## Voluntary Carbon Standard Version 2007 Verification Report Template

Report No.: 8000361518 - 08/188 - V02

| Verification Report - Yangcun Hydropower Project                                                                                                                                                                                                                                                                                                                                                                                                                                                                                                                                                                                                                                                                                                                                                       | Mr. Winter Rainer          |
| South Pole Carbon Asset Management Ltd.

Figure 1: Wiring diagram as indicated in the monitoring report, page 6

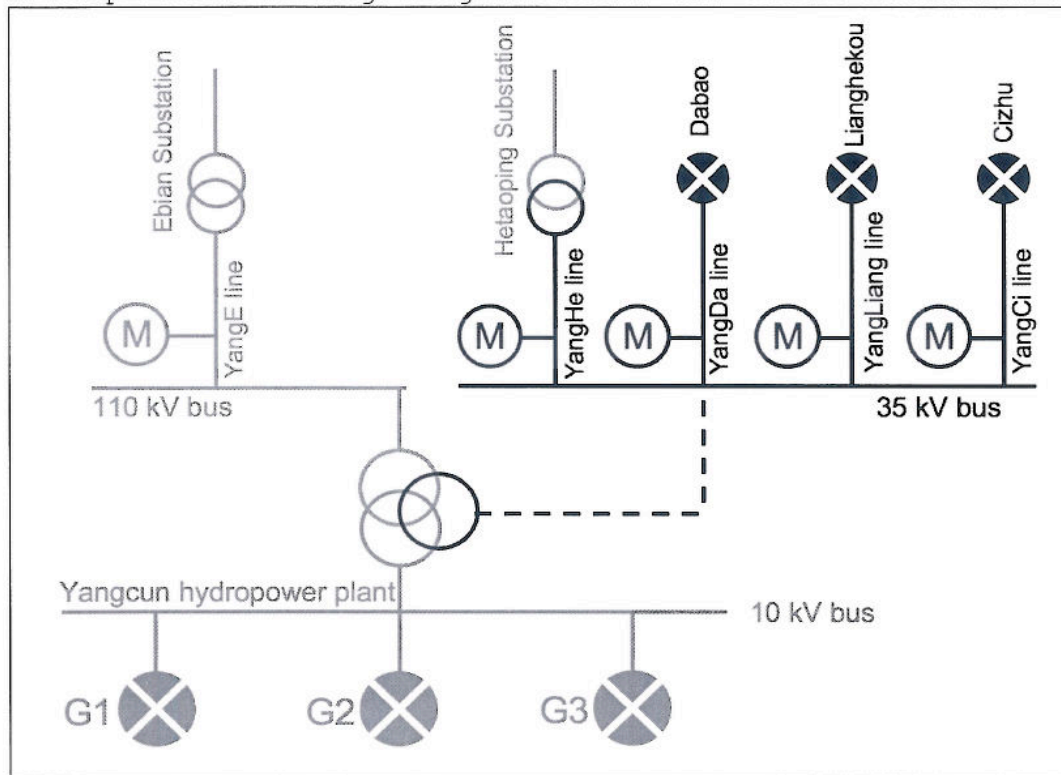
**CAR1:** More information e.g. meter reading time, calibration, accuracy etc. of the meters involved in the monitoring system esp. meter for *Elec<sub>import,35kV</sub>*, and *Elec<sub>Hetaoping,y</sub>* etc. should be demonstrated clearly in the MR.

**CAR2:** The monthly records for electricity imported from the 35KV bus line (Yangda and Yangzi line etc. should be provided).

**Corrective action:** Detailed information of the meters is provided in Annex I of the report. The emission reduction is calculated accordingly.

**Conclusion:** The meter information as well as the calculation were checked by the verification team and assessed to be correct.

**Corrective action:** The monthly records for electricity imported from the 35KV bus line were provided to the verification team.

**Conclusion:** The submitted records which were confirmed by the grid company (Sichuan Dadu River Electric Power Co., Ltd.) were checked and assessed to be credible.
